COMMITTEE OF ADJUSTMENT STAFF REPORT

RE: Minor Variance Application
Pontisso
10 Jasper Drive
PLAN 517, LOT 141
File: MV-2020-16

Proposed Front Elevation

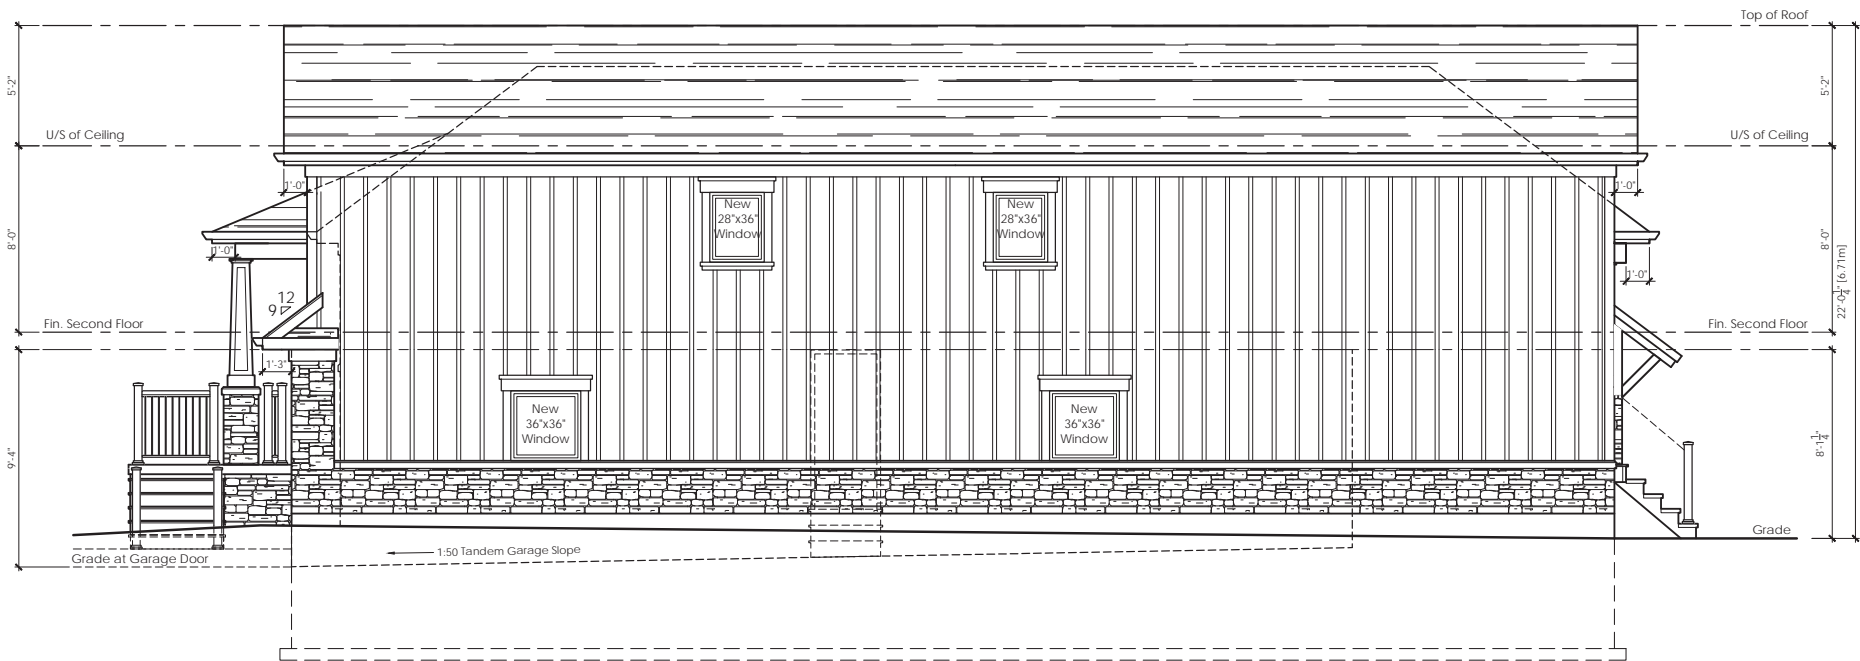
The applicant is proposing to maintain the existing front yard setback to the dwelling for the addition. Additionally, the applicant has integrated the garage into the design

of the dwelling by ensuring that the proposed addition is generally flush with the existing main wall of the building, and by including a second storey above the garage which de-emphasizes the visual impact of the garage.

The proposed reduced front yard setback for the proposed porch (with steps) extends beyond both the face of the main wall of the existing building and proposed addition. The enlarged porch allows for additional enjoyment of the front yard (i.e. seating area) while also enhancing the streetscape.
